# RENESAS TECHNICAL UPDATE

Product Category	MPU/MCU		Document No.	TN-SH7-A714A/E	Rev.	1.00
Title	Omitted Description in Passages on Conditions for Clearing the TEND, TDRE, and RDRF Bits in the SSU Module		Information Category	Technical Notification		
Applicable Product	SH7147 Series products	Lot No.	Reference Document	See below.		
		All lots

We would like to inform you of omissions in the descriptions of conditions for clearing the TEND, TDRE, and RDRF bits in the SSU module of applicable products.

Figure 14.4 Example of Initial Settings in synchronous Serial Communication Mode

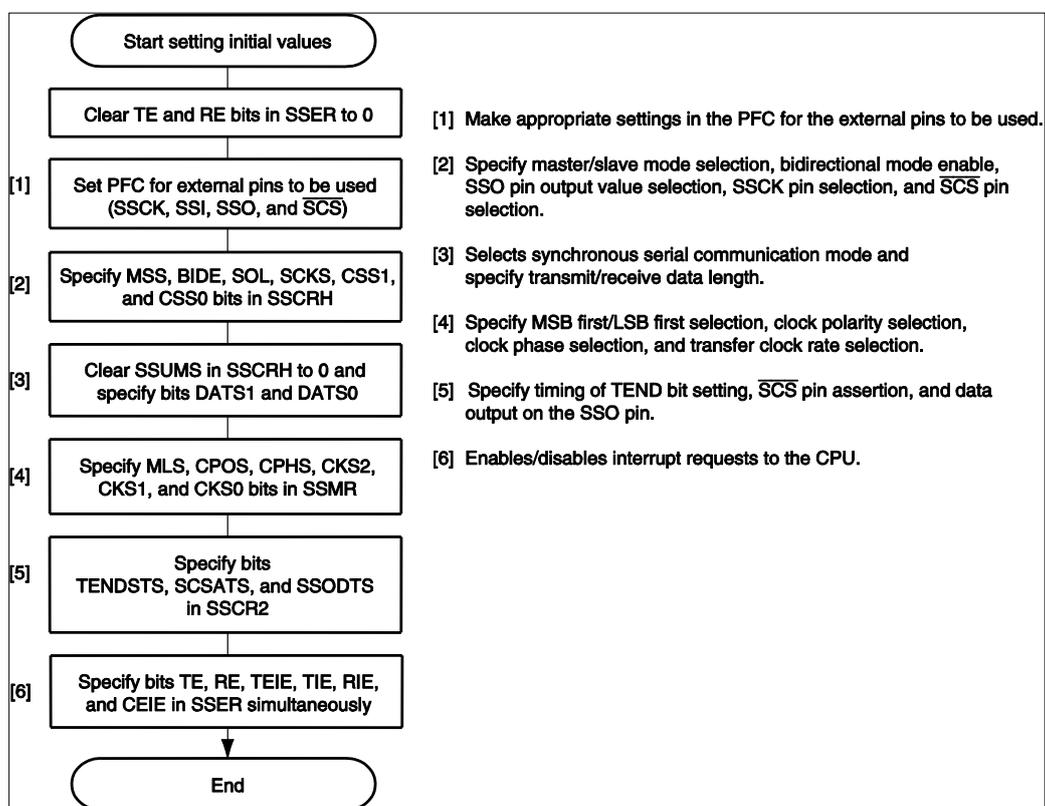
[Before change]

Figure 14.4 Example of Initial Settings in synchronous Serial Communication Mode

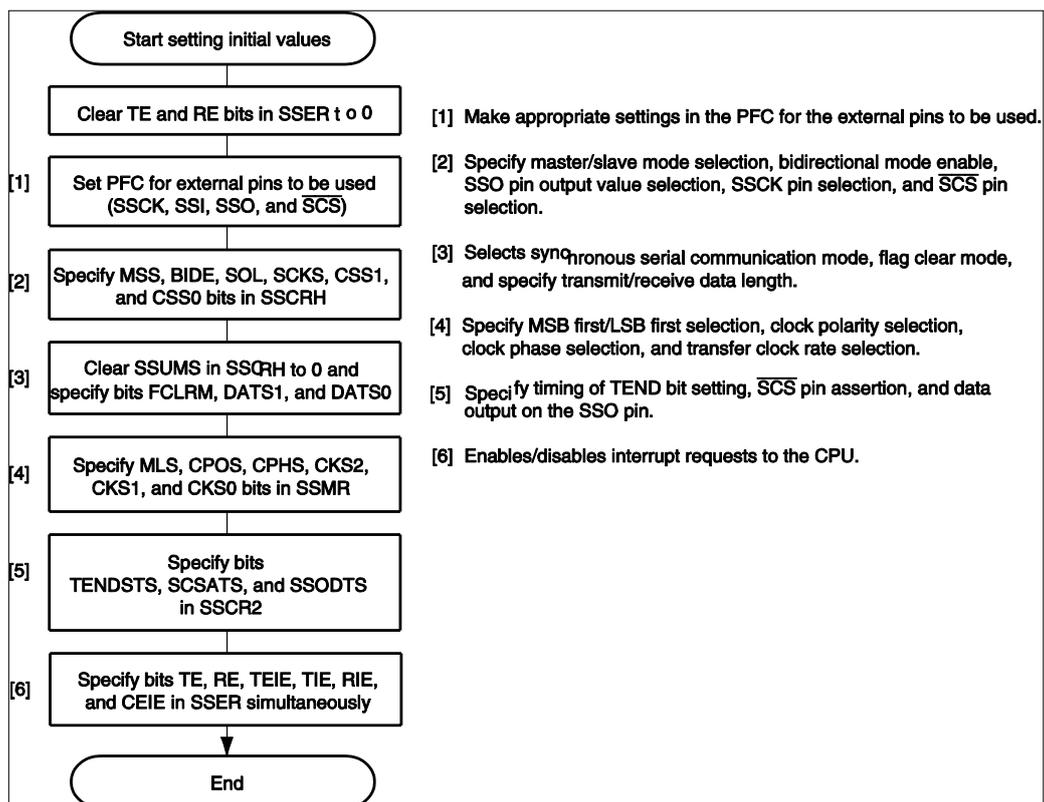
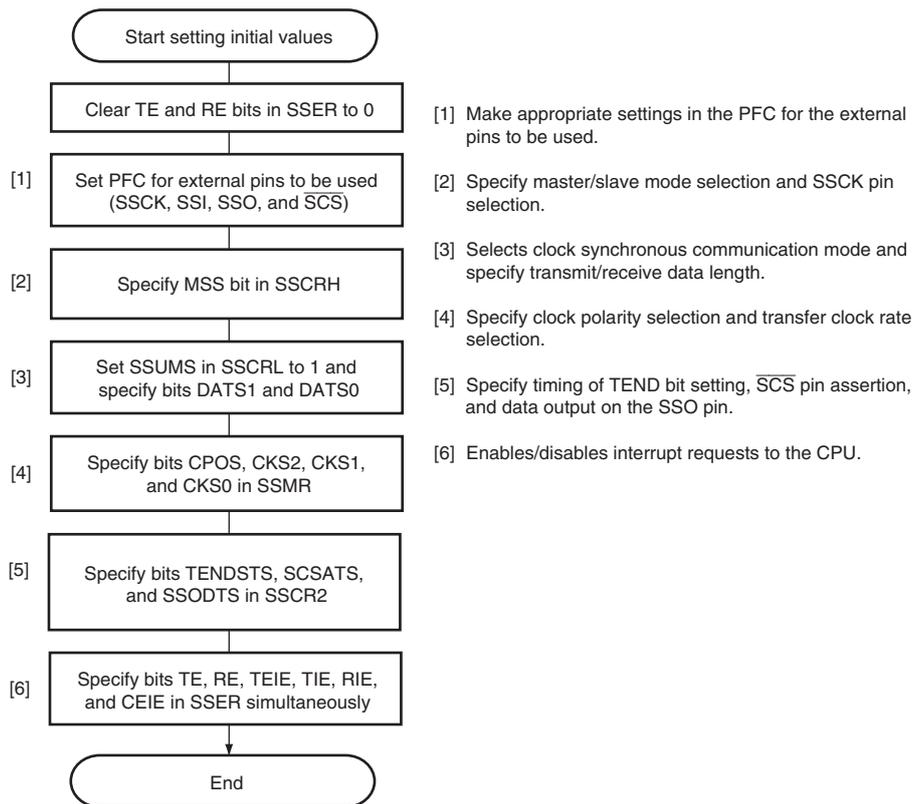
[After change]

Figure 14.12 Example of Initial Settings in Clock Synchronous Communication Mode

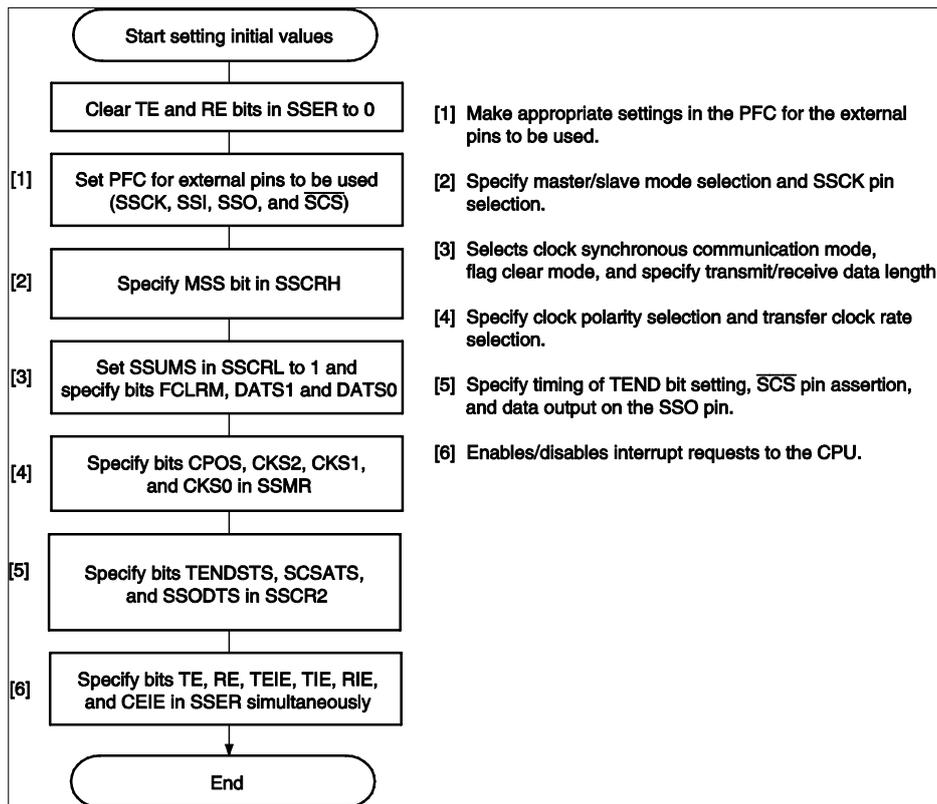
[After change]
